Project	CMHA Meadows RAD Renovations	Addendum Number	2
Project Number	18076.04	Date	09/12/2025
To	All Bidders		
<i>This addendum contains changes to the requirements of the bidding Documents, Project Manual and Construction Drawings which have been issued to date. Such changes are to be incorporated into the Construction Documents and shall apply to the work in the same meaning and force as if they had been included in the original documents. Wherever this Addendum modifies a portion of a paragraph of the Project Manual or a portion of any Drawing, the remainder of the paragraph or Drawing shall remain in force.</i>			
General	Clarifications: <i>Bid Form: See attached revised bid form showing line item for permit fee included.</i> <i>Do the gas lines in the laundry room need to be removed? Is the furnace the only gas fed item within the unit?</i> Response: Gas lines are stubbed into the laundry area for future use of a gas appliance. No work is to be done on the gas lines in the laundry room as a part of this renovation. <i>How should the curb be addressed where the sidewalk on the accessible route widens?</i> Response: See Civil drawings updates as a part of this Addendum. <i>Do y

FIRST FLOOR UNIT 2-A
HVAC PLAN
SCALE: 1/4"=1'-0"

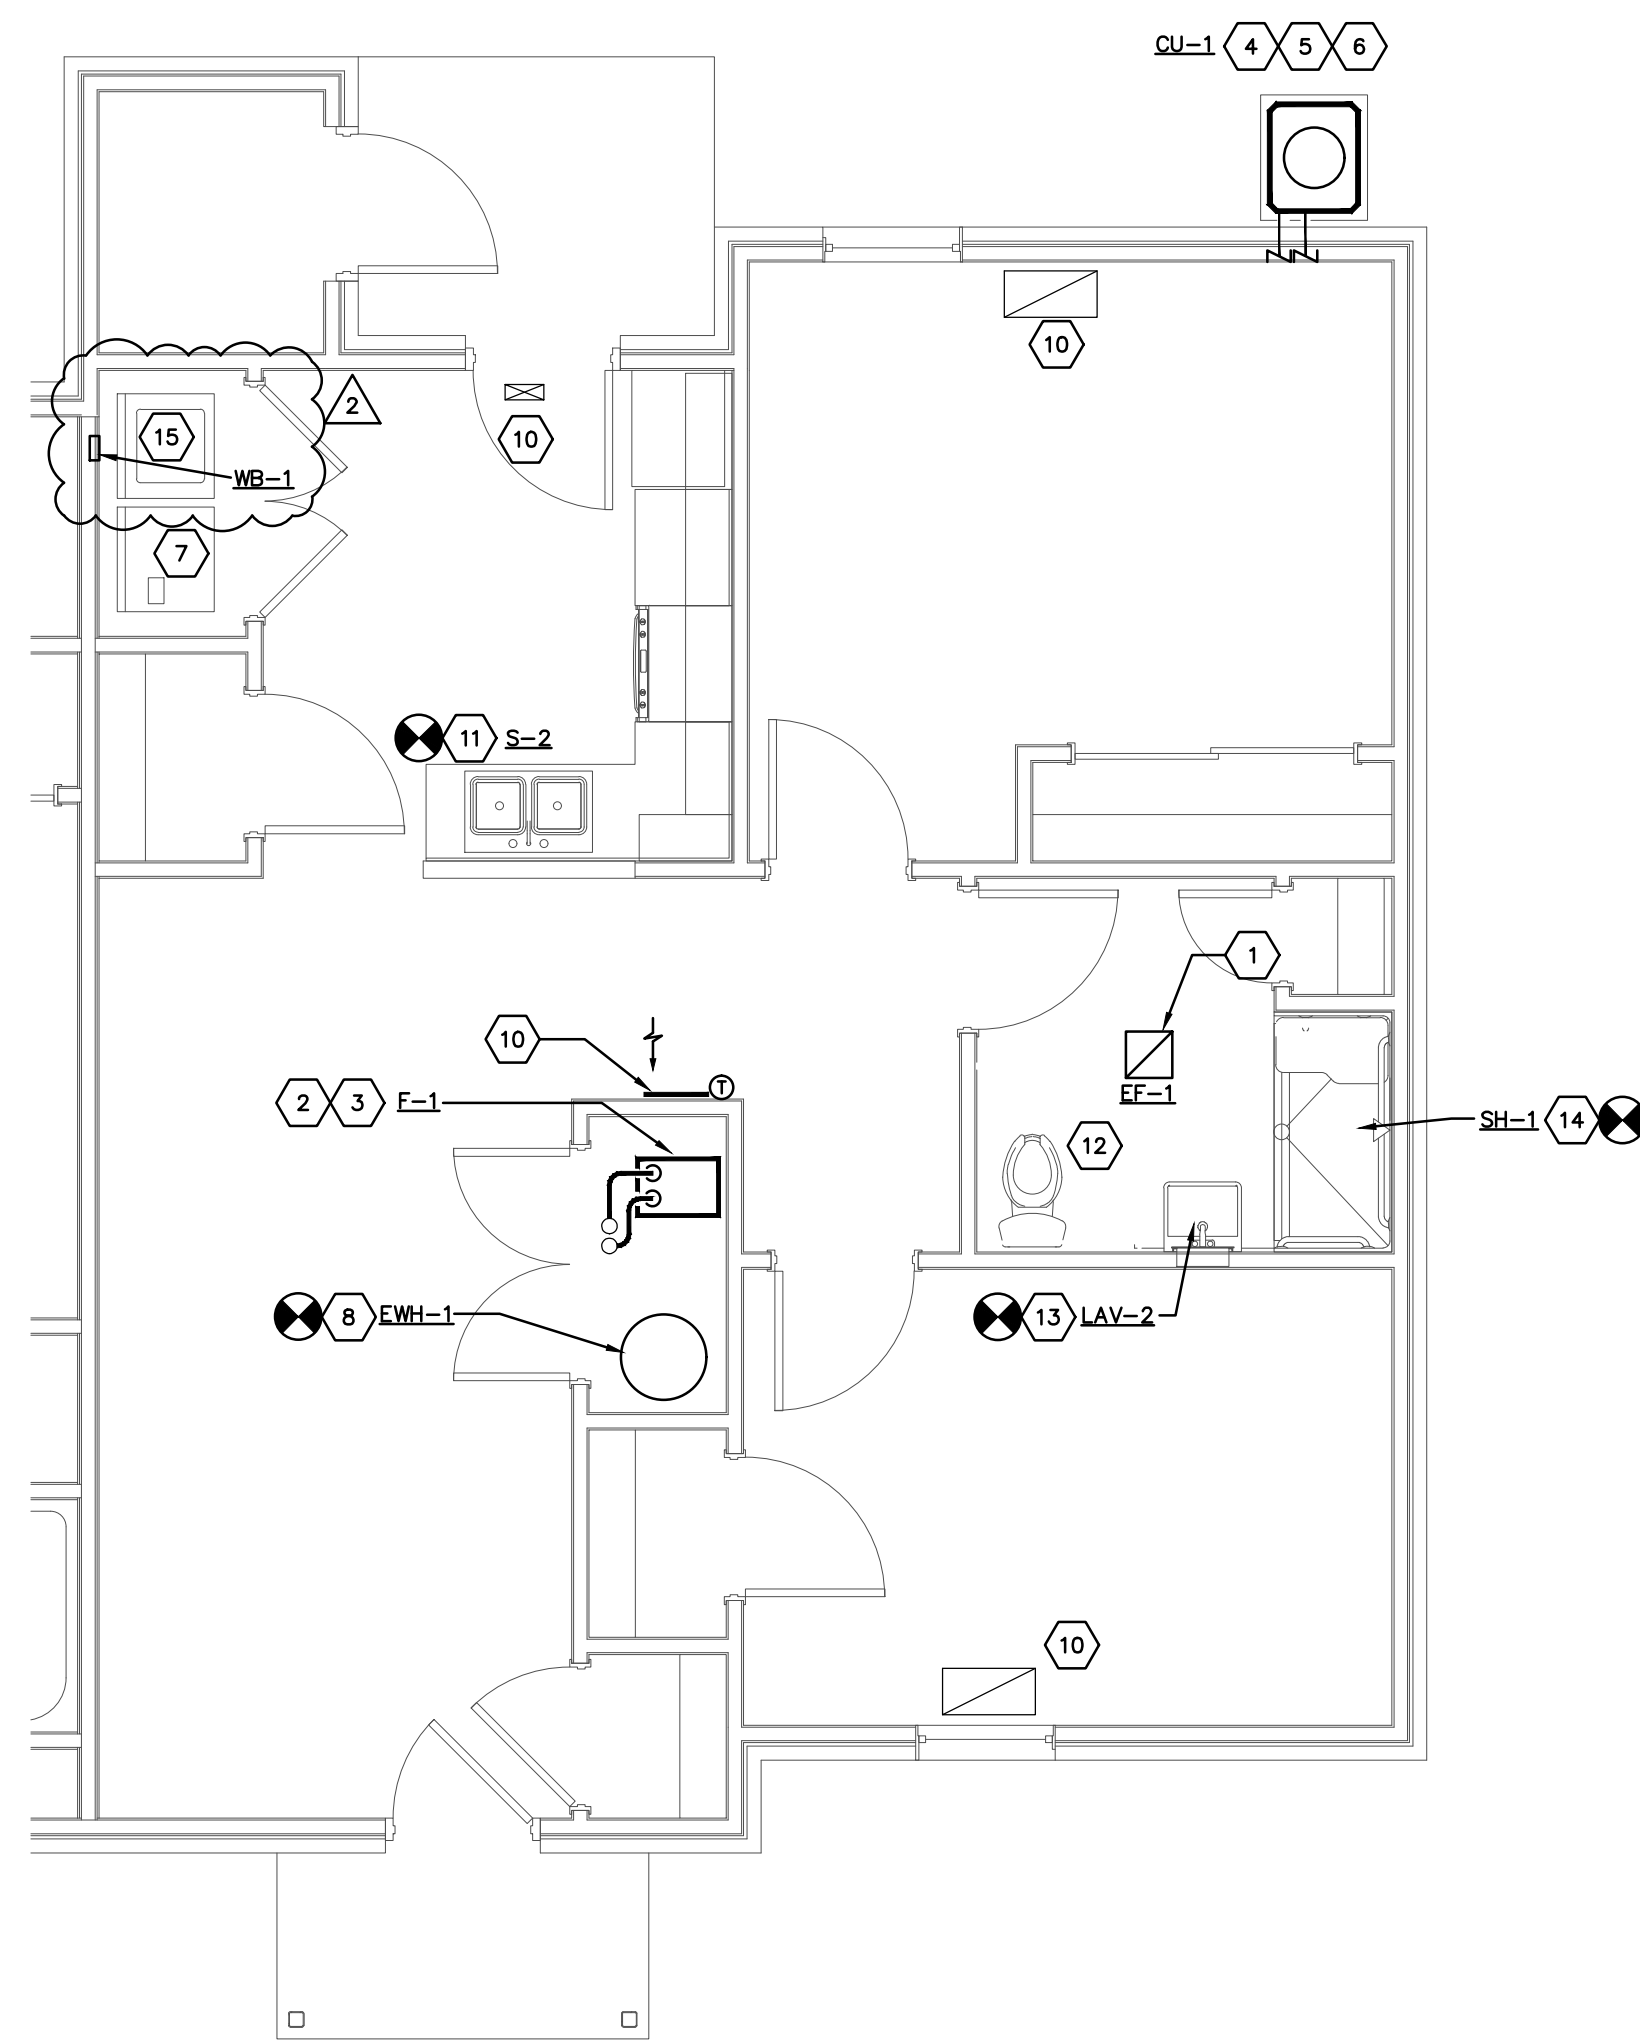
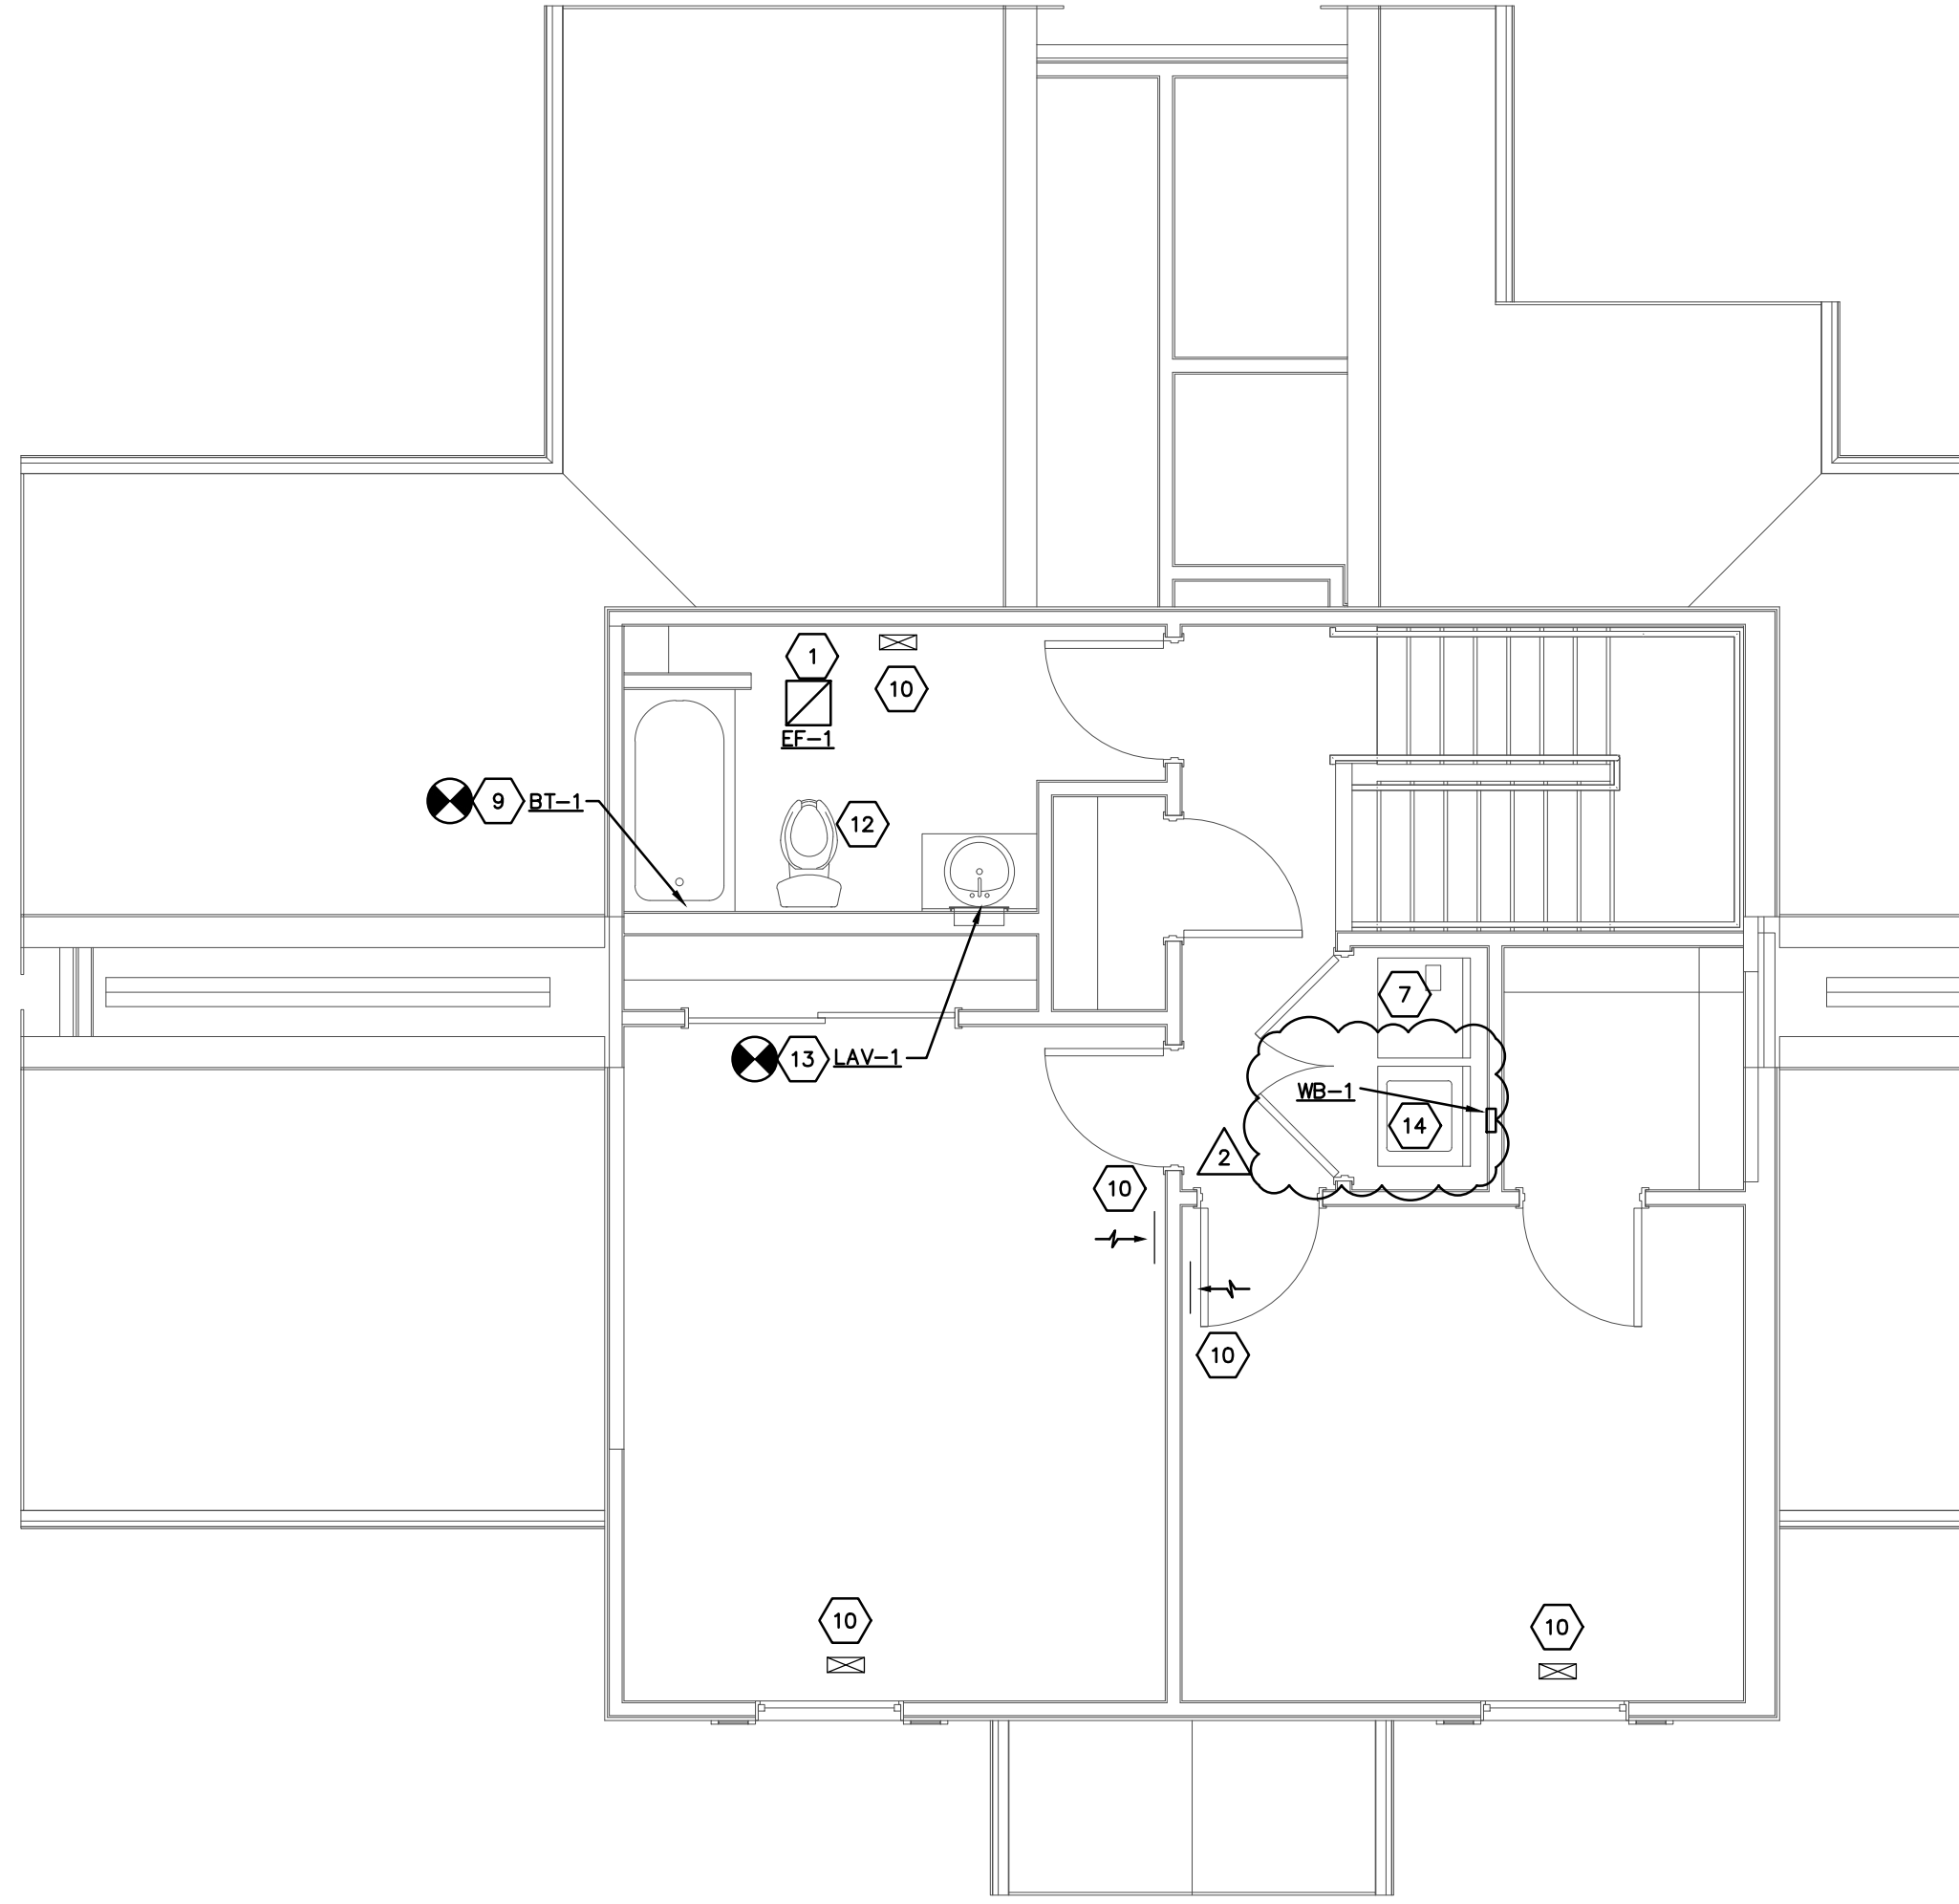
1. ADDED WB-1 washer box replacement in Unit 2-A first floor, Unit 2-B first floor, and Unit 3-A second floor.
2. ADDED Coded Note #15.

- REPLACE EXISTING WASHER BOX AT THIS LOCATION. FIELD VERIFY EXACT LOCATION. SEE "PLUMBING FIXTURE SCHEDULE" ON SHEET H900.
